DEVIATION REQUEST AND DECISION FORM

Project Name :	Crossroads North
Schedule No.(s) :	5408001008, 5408001029, 5408001032, 5408001033, 5408001034, 5408001041, 5408001042, 5408001050, 5408001051, 5408001052
Legal Description :	LOTS 12, 13, 14, 15, 16 AND 18, HILLCREST ACRES, ACCORDING TO THE PLAT THEREOF RECORDED MAY 12, 1960 AT RECEPTION NO. 153860, EXCEPT THAT PORTION ACQUIRED BY THE DEPARTMENT OF TRANSPORTATION, STATE OF COLORADO AS DESCRIBED IN RULE AND ORDER RECORDED APRIL 28, 2004 UNDER RECEPTION NO. 204068322, AND EXCEPT THOSE PORTIONS CONVEYED TO EL PASO COUNTY BY AND THROUGH THE BOARD OF COUNTY COMMISSIONERS OF EL PASO COUNTY, COLORADO BY SPECIAL WARRANTY DEED RECORDED DECEMBER 17, 2014 AT RECEPTION NO. 214116021 AND RECORDED DECEMBER 17, 2014 AT RECEPTION NO. 214116022, COUNTY OF EL PASO, STATE OF COLORADO. LOT 17, HILLCREST ACRES, COUNTY OF EL PASO, STATE OF COLORADO, EXCEPT THAT PORTION CONVEYED TO EL PASO COUNTY BY AND THROUGH THE BOARD OF COUNTY COMMISSIONERS OF EL PASO COUNTY, COLORADO BY SPECIAL WARRANTY DEED RECORDED DECEMBER 30, 2014 AT RECEPTION NO. 214119767. LOT 19, HILLCREST ACRES, COUNTY OF EL PASO, STATE OF COLORADO, AS AMENDED BY SURVEYOR'S STATEMENT RECORDE

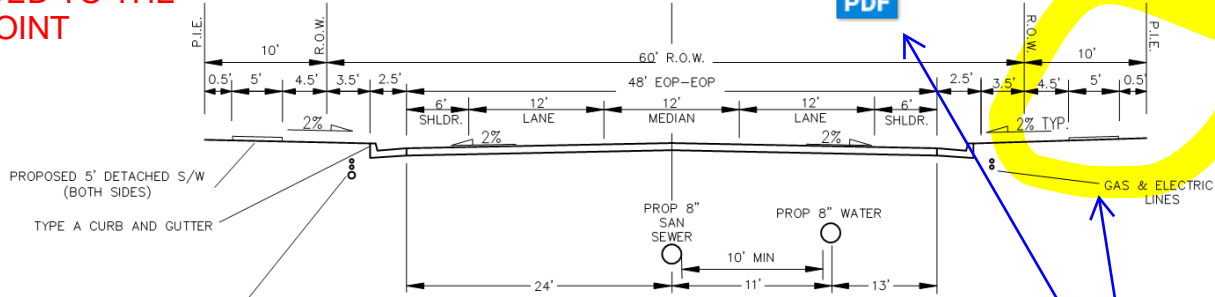
Revise. Air Lane is public road. Unresolved

THIS HAS BEEN REVISED TO "PUBLIC ROAD".
